Access Compliance Report

Public Rights-of-Way

Intersection ID: 31907	Main Street: PALOMAR_MOUNTAIN_DR	Cross Street: SPRUCE_PEAK_RD	Location: NW
ADA ID: C19186D87712	Ramp Type: PerpDiag	Initial Pass/Fail: Fail	Overall Compliance: No
Severity Score: 8.75			
Codes/Mitigation Info/Possible Solution		Field Measurements/Component Compliance

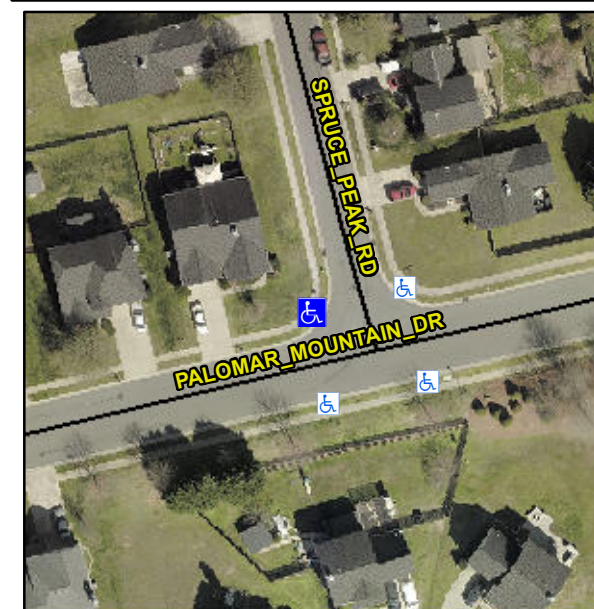
R304.5.1

Remove & Replace Curb Ramp With Two New Directional Ramps or Equivalent.
